REV.  
E

AS3252™

BOLT, MACHINE - DOUBLE HEXAGON EXTENDED WASHER HEAD, DRILLED, PD SHANK, SILVER PLATED, NICKEL ALLOY, UNS N07718, 185 KSI MIN, .3125-24 UNJF-3A

ISSUED 1980-07 REAFFIRMED 2007-06 REVISED 2020-01

FIGURE 1 - BOLT

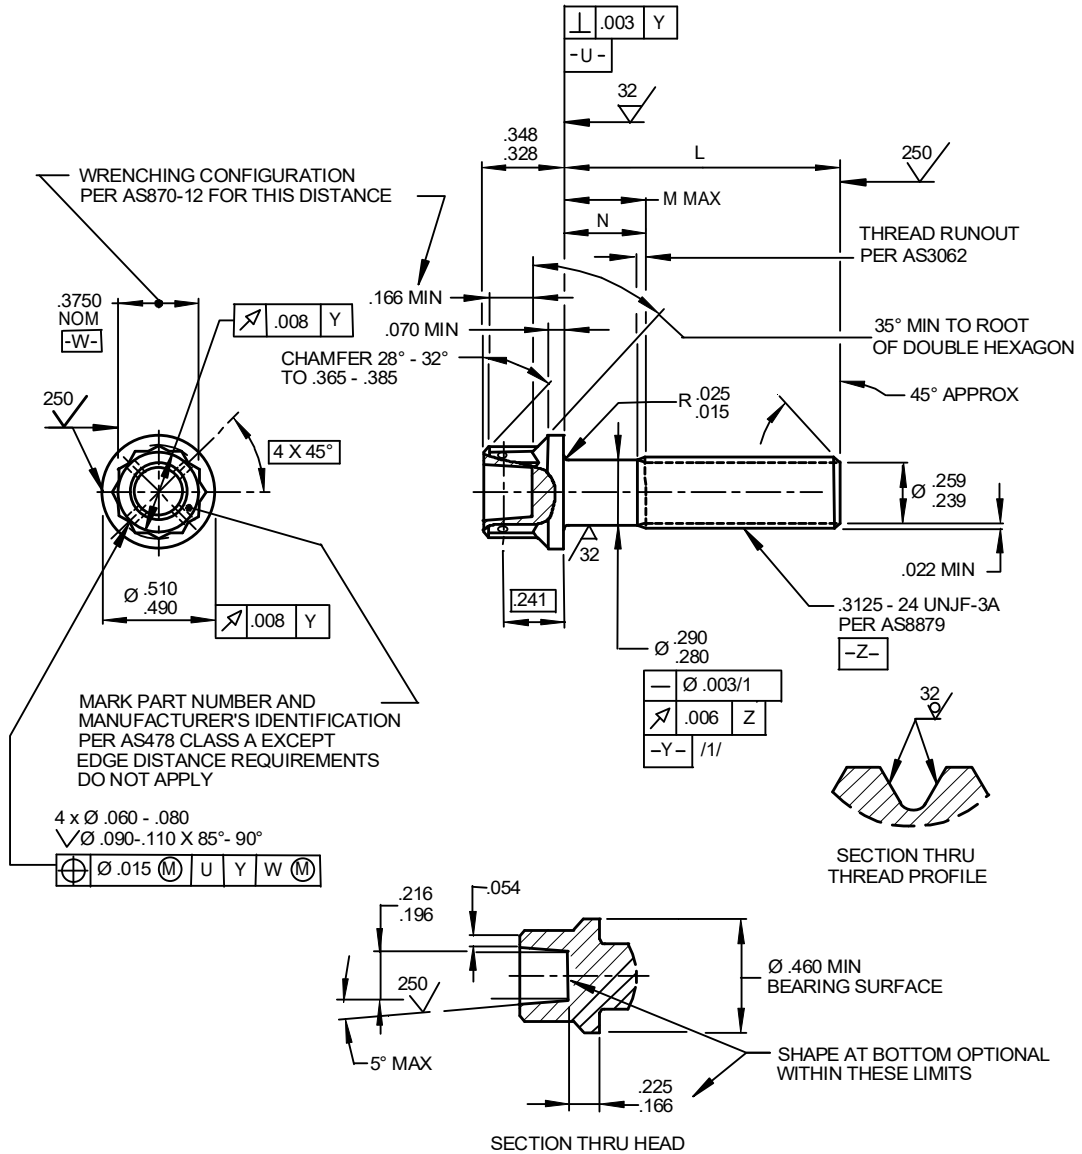
CORRECT THREAD END CHAMFER AND LIGHTENING HOLE DIMENSIONS TO AS1132, USAGE NOTE ADDED, SPECS UPDATED.
